DETAILED ACTION

Art Unit: 3771

Prior Art
US 2,521,084
Oberto

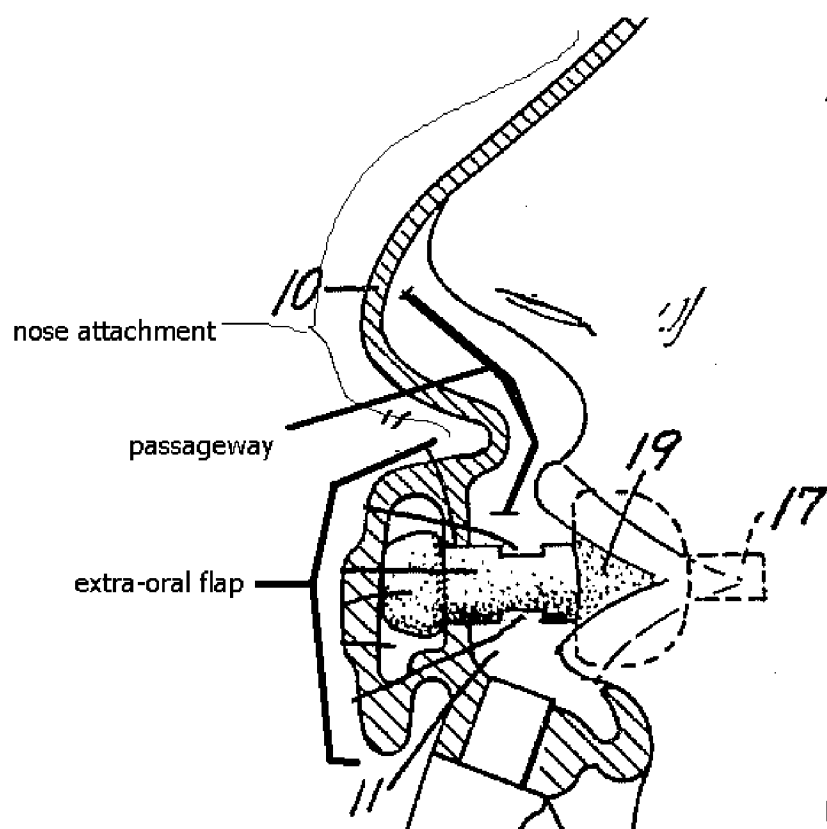
As to claim 60, Oberto in figure 1 shows there is a passageway formed between said extra-oral flap (also see labeled figure1 attachment below). Figure 1 of Oberto shows that the position of the passageway leaves a space between the user's nasal cavity and the nose flap and this space allows gases coming from oxygen hose (14) and port (24) to enter nasal cavities. Thus, Oberto's nose flap is structured to allow a user to breathe gases through their nasal cavities.
